***MODIFICATION REQUEST:
Sydney CityGrid Stage 1 – Belmore Park
Zone Substation -Through Site Link
Haymarket
MP 08_0075 MOD 1***

Director-General's
Environmental Assessment Report
Section 75W of the
Environmental Planning and Assessment Act 1979

December 2012

Figure 4: Proposed Modified Layout (eastern boundary of the site to be now publicly accessible)

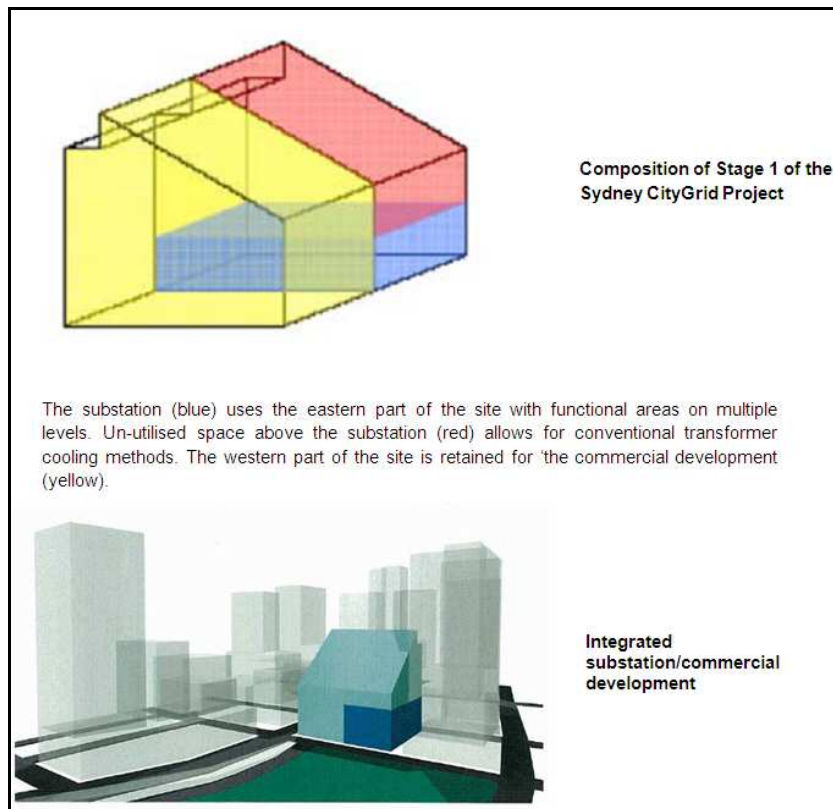
The link is to comprise of granite paving and pole lighting, with trees situated along the eastern side of the link (refer to Figure 4 above).

Additionally, lighting should accord with the relevant Australian Standards. The typical post top light fitting is approximately 4 metres high. It is suggested the stratum reflect this height at a minimum (6 metres would be preferred). Lower lights, as sketched are not desirable.

Materials, furniture and lighting should be consistent with Sydney Street & Sydney Lights Design Codes (granite paving) to reinforce the public route.

Tree planting to follow standards established in the Street Tree Master plan, including installation size, planting hole depth and width preparation, sub soil drainage etc. The City's Arboricultural Services team could advise and appropriate species, consistent with the master plan proposals for adjacent streets.

Finally, In lieu of a glass balustrade, it is recommended a metal palisade design be explored.

- 2.1A The Proponent shall prepare and implement a **Through-site Link Design and Safety Management Plan**, in consultation with the Council, detailing the measures to mitigate and manage security and design issues associated with the operation of the link including, but not necessarily limited to:
- a) measures to mitigate and manage security hazards (such as the closure of the link during night periods or the installation of CCTV surveillance camera(s) at strategic points within the link);
 - b) design and lighting treatments; and
 - c) landscaping treatments.

- 2.1B The Proponent shall ensure the design and landscaping treatments required under condition 2.1A of this approval include:
- a) public domain materials to express that the through-site link provides public access; and
 - b) appropriate native plantings of trees and shrubs to suit the environment of the eastern section of the site.
